#### **Bid Addendum No. 1 for:**

#### MASON TRANSIT AUTHORITY - LOG YARD ROAD AND SR 3 ROUNDABOUT PROJECT

io: All Prospective Bidders
From: Patrick Holm, PE
RE: MASON TRANSIT AUTHORITY – LOG YARD ROAD AND SR 3 ROUNDABOUT PROJECT
All Bidders are required to make the following substitutions to the Bid Documents. Below is description of the revisions made to the Contract Documents.
Plans:
☐ Replace the following Plan Sheets with new Plan Sheets:
☐ Sheet CV: ☐ Updated Sheet Index
Volume II  Sheet EC-1:  ☐ Add notes for protect and preserve existing water line. ☐ Details referenced on EC-2 can be found on RM-6.
Sheet SD-1: ☐ Added Water Main Extension to plan.
Sheet WA-2: ☐ Added Water Notes to plan set.
Bid Package:
☐ Appendices ☐ Appendix C — Cross Sections has been added.
Special Provisions:
☐ Section 1-08.5 Time for Completion ☐ Revised working days from 90 days to 120 days.

#### CONCRETE BLOCKING

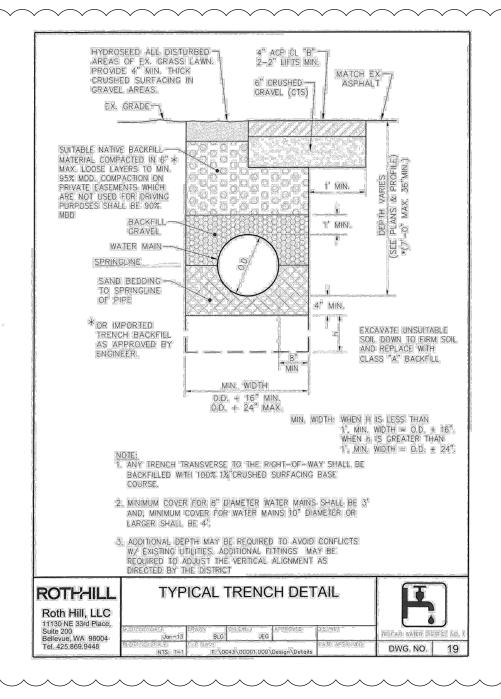
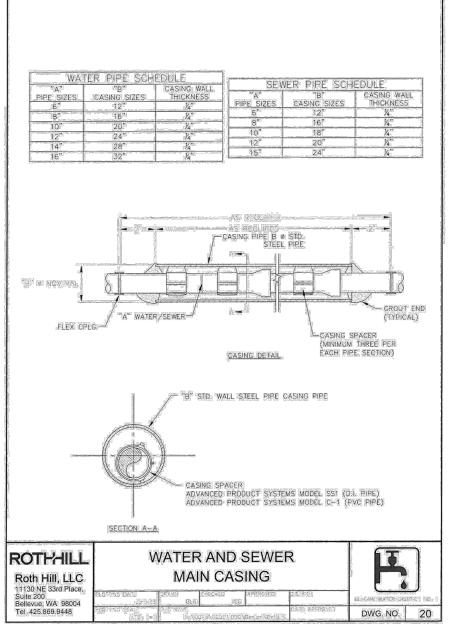
DESIGNED BY N. MAYFIELD 10-31-2018 1 BID ADDENDUM #1 09/13/19 PH JOB No.: N. MAYFIELD 0738.05 UNLESS OTHERWISE RAWING FILE No.: 0738.05-WA-2-B P. HOLM
